MEMORANDUM

Project: 4706 E. Washington Ave. Redevelopment
Regarding: Site Option Study per UDC request/comment

**4706 E WASHINGTON AVENUE
GRADIGN PLAN**

C3.0

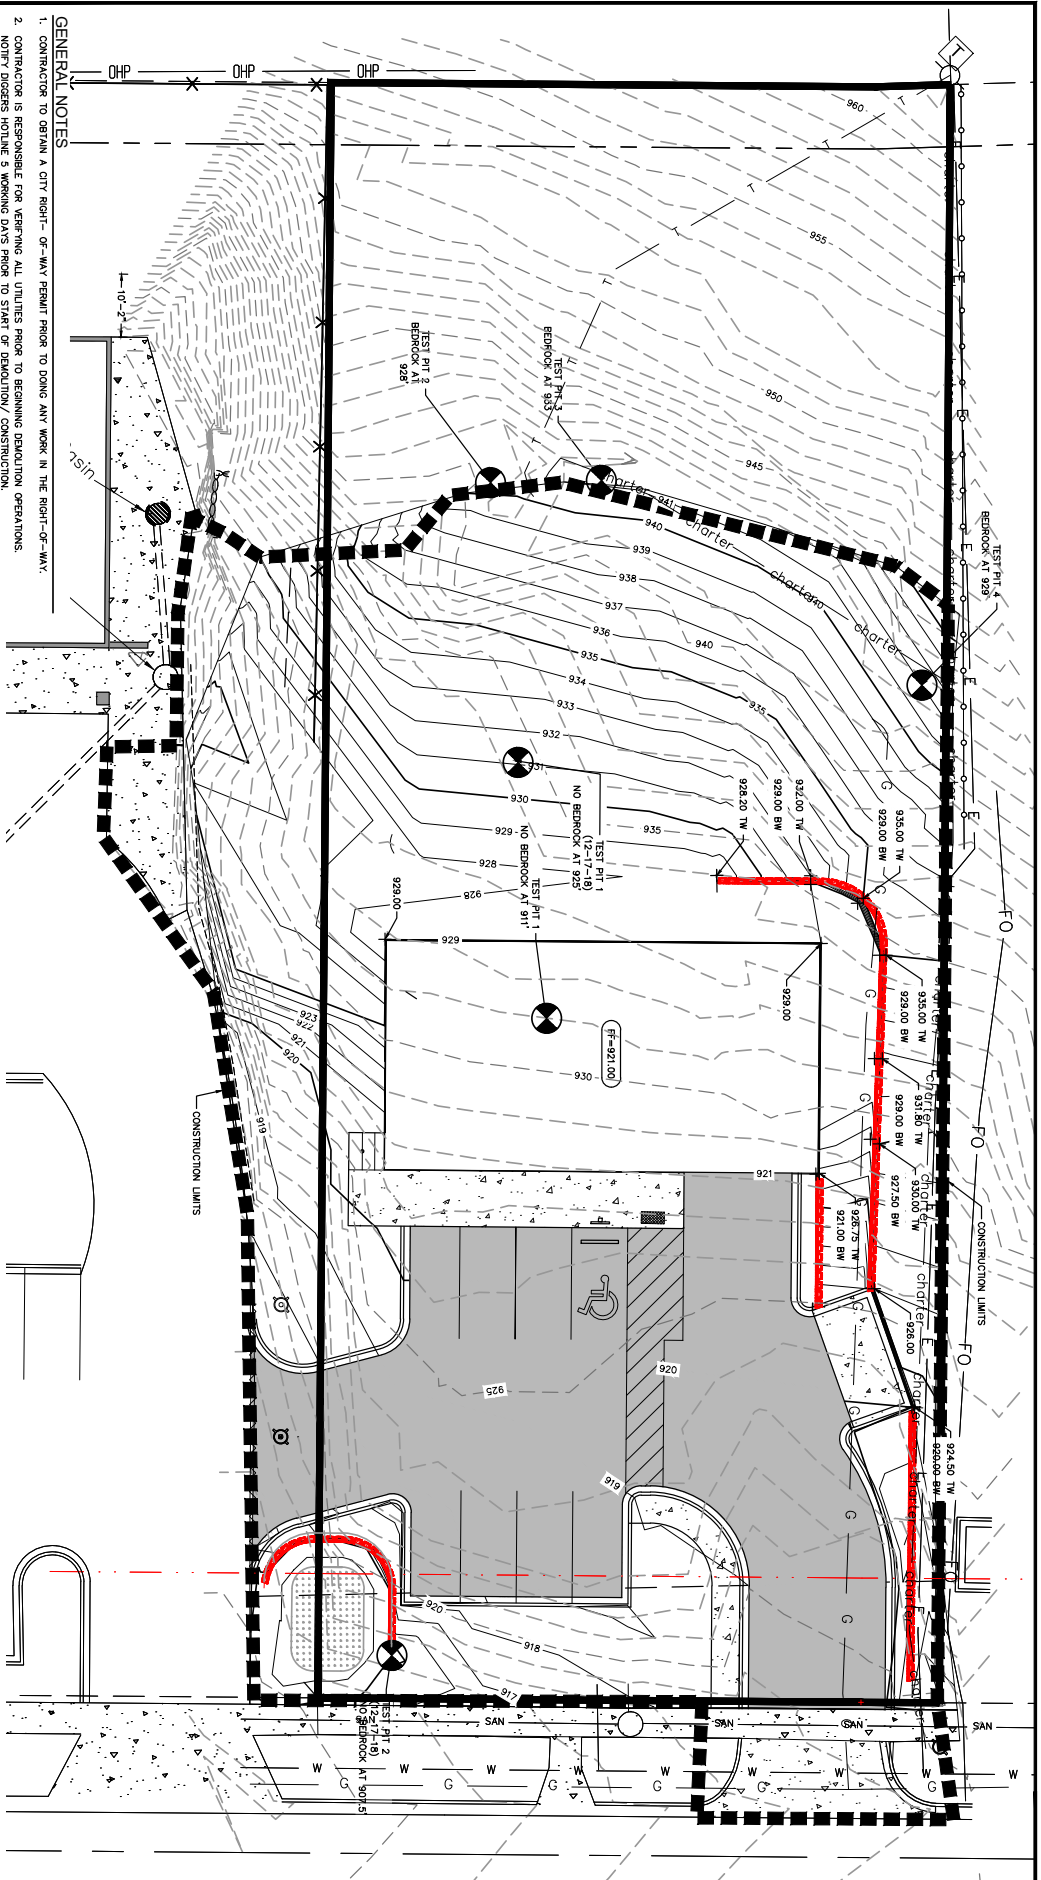
At the February 27, 2019 meeting, the committee reviewed the redevelopment project proposed at 4706 E. Washington Ave. and ultimately referred the project based on the premise that what was proposed does not meet the intent of the zoning code having its primary entrances facing the street. Suggestions from the committee included placing the building to the north of the property with parking along the street to ensure the street front was considered the main entry side.

We have reviewed the UDC comments and tested several site options that could meet the requirements. What we confirmed is that the building loses significant amounts of parking, delivery access, and ADA/pedestrian access to the redevelopment. Included in this memo is an example of such layout. Based on the requirement to push the building to the north with parking in front – access to the rear of the building for exiting is all but eliminated due to the excessive change in grade as you move further north on the site without excessive excavation and blasting. Due to exiting distances, doing so required a reduction in building square footage, thus a smaller footprint and reduced revenue to support the redevelopment. Trash would need to be relocated to the south parking lot, as well as maintaining the drive access onto the property for deliveries. In order for a delivery truck or semi to access the building and navigate the site, the existing drive access would be required, thus reducing the amount of parking available on the property. Zoning has requested this existing drive access point remain closed due to the adjacency to the property to the east and west. As seen from the concept plan attached, the parking lot becomes inefficient and requires a ramp to the adjacent property that exceeds a 4 ft. grade difference make vehicle movements difficult so close to the adjacent property drive entrance. Required ADA access would require the public to cross the parking lot from the street to gain access. The balance of grade change between the adjacent properties with the parking to the front is difficult to manage taking into consideration vehicle access and maintaining ADA access.

The project we are resubmitting has taken an approach that the main building entrances are more focused on the street. Parking continues to be on the north, with the building to the south along the street as preferred by Zoning. The design has taken several steps to provide a better pedestrian connection from the street and adjacent parking lot with a access stair and relocating the bicycle parking to the front of the building. We have also incorporated a small patio to encourage a future tenant to have outdoor seating. Architecturally, the primary focus is on the street front with larger entry canopies, lighting, and larger amounts of glazing exceeding zoning ordinance minimums over the rear exit doors. We feel the collective of smaller gestures greatly enhances the street front façade and exceeds the requirements set forth by the Zoning code and UDC requests.
